PITTS AVIATION ENTERPRISES, Inc.

SERVICE LETTER NO. 2

Subject: Reinforcement of flapper door of alternate air heat box assembly. P/N 2-7112-12.

Subject: Inspection of upper wing front spar to cabane fitting, P/N 1-410-12.

2-7112-16 STIFFENER
 FLAT PATTERN FULL SIZE

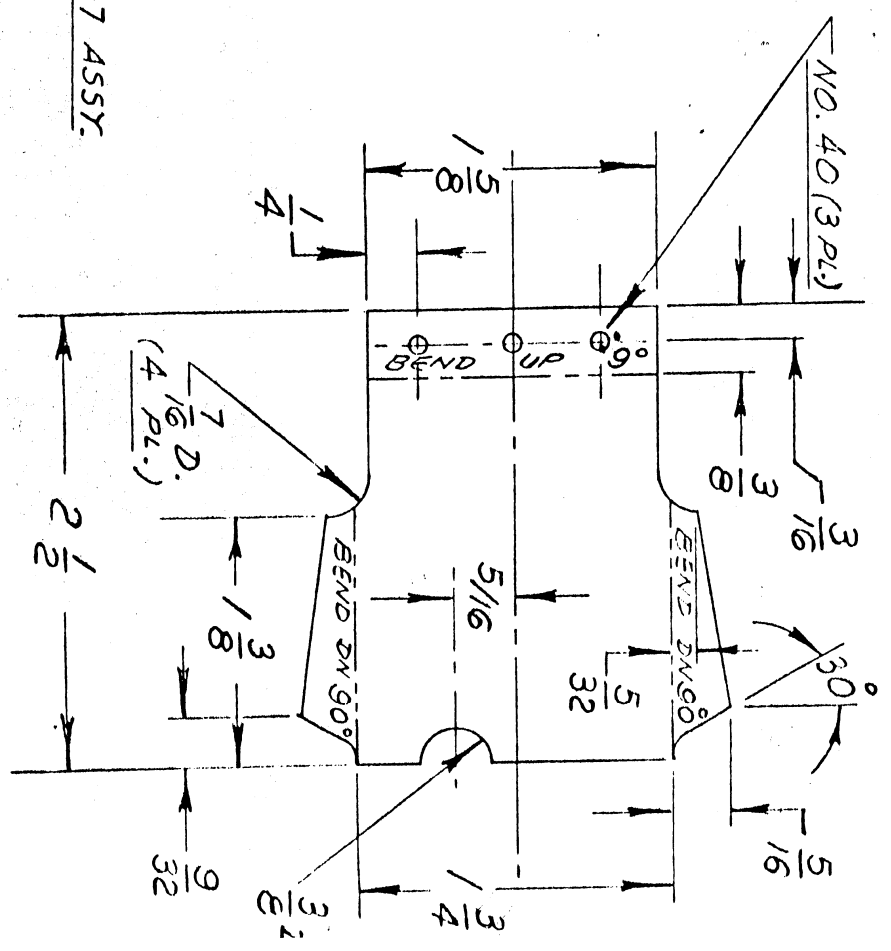
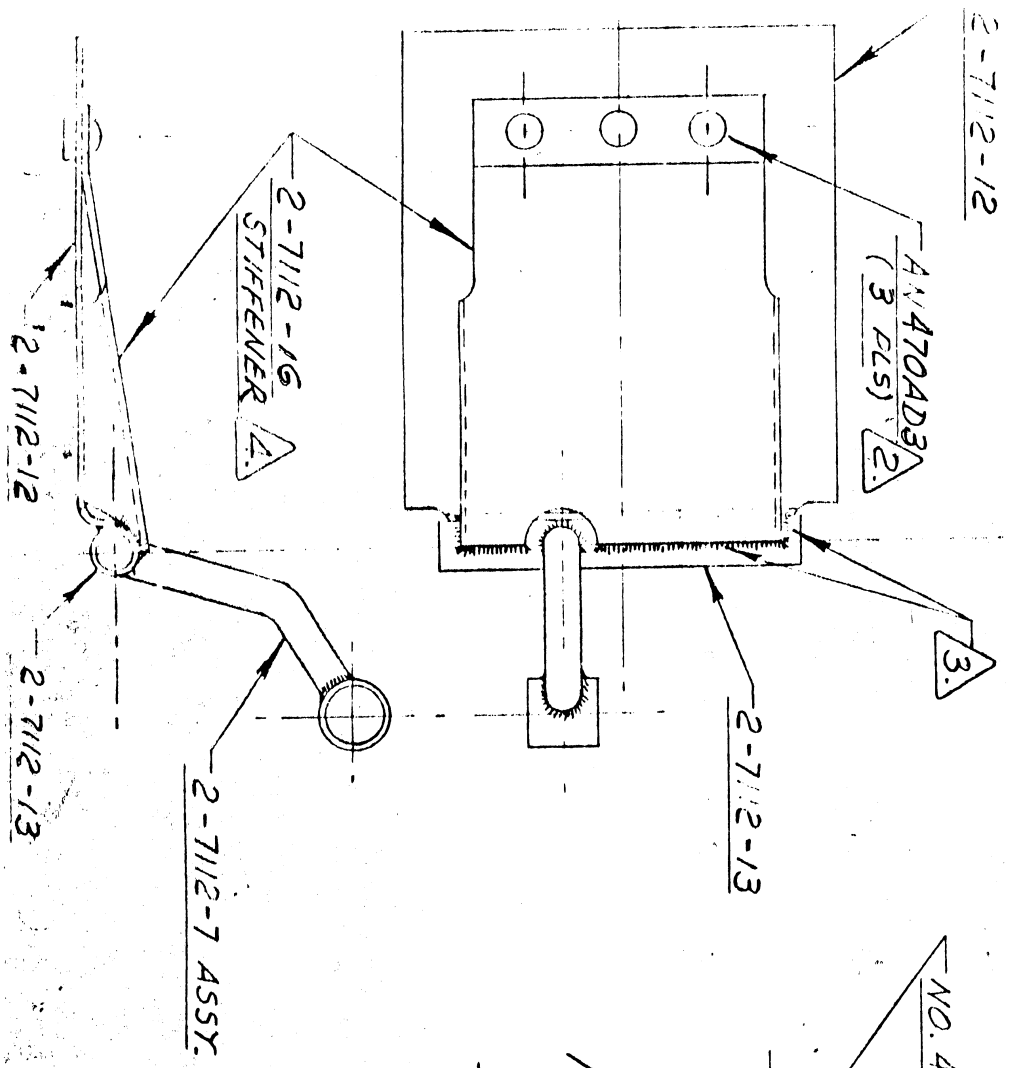
General: The addition of the P/N 2-7112-16 stiffener (shown on sheet 2. of 2. of this service letter) will be made on production Model S-2A airplanes from Serial No. 2060, and up.

We do not believe at this time that the likelihood of failure of this unreinforced element is sufficiently high that a mandatory Service Bulletin is justified; however, we do suggest that your present flapper door be checked to see if cracks exist next to the hinge line. If so, the cracks should be welded shut and the 2-7112-16 stiffener added, as shown on sheet 2. of 2. (on reverse side).

1. REF. DWG. NO. 2-7112, NC, 3-18-71. THE ONLY ADDITIONAL PARTS REQ'D ARE:
 2-7112-16 (1 REQ'D) AND AN470AD3 (3 REQ'D).
2. ALIGN 2-7112-16 AS SHOWN & DRILL (3) NO. 40 HOLES IN 2-7112-12, USING HOLES IN -16 AS GUIDE. INSTALL (3) AN470AD3 RIVETS AS SHOWN.
3. WELD -16 TO -13 AS SHOWN ONLY ALONG INDICATED EDGE, AND ON ADJACENT EDGES GOVT DOWN TO CENTERLINE OF -15. DO NOT WELD -16 TO -12. MAKE FROM 430W STEEL PER MIL-S-18729, .025 X 2 1/2 X 2 3/8. MIN. BEND RADIUS 1/16. TWO 90° BENDS TO BE ACROSS GRAIN OF -16.
- 4.

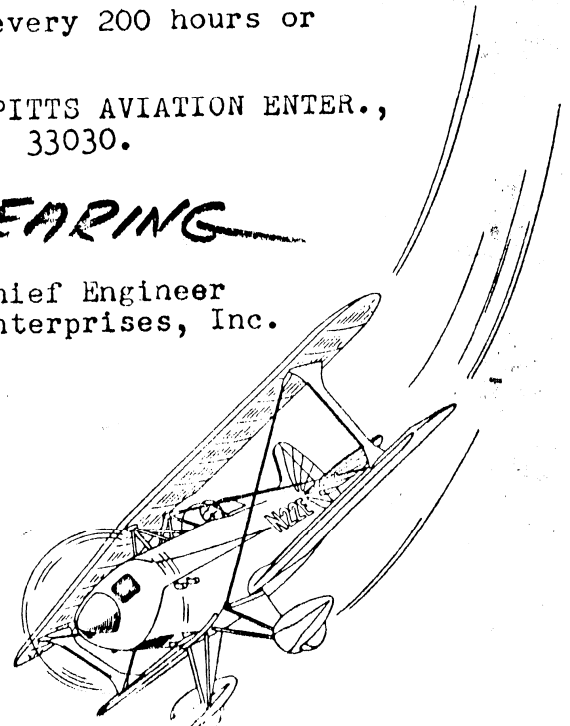
We believe it would be prudent to inspect these fittings for the presence of cracks.

In order to accomplish the inspection, it will be necessary to remove all paint and fabric on the fittings below the wing lower surface contour. (Removal of the AN5 bolt is not necessary.) Inspect the front and back faces of both fittings for cracks, especially in the area immediately above the AN5 bolt at the lower end of the fitting. Dye-penetrant and, or a ten-power glass may be used.

If cracks are noted, replace these fittings before further flight. If no cracks are present, re-finish bare metal surfaces exposed for the inspection.

If you wish to replace your 1-410-12 upper wing front center section fittings, the replacement part no. is 1-410-85; available from Aerotek, Inc., P.O. Box 547, Afton, Wyoming 83110
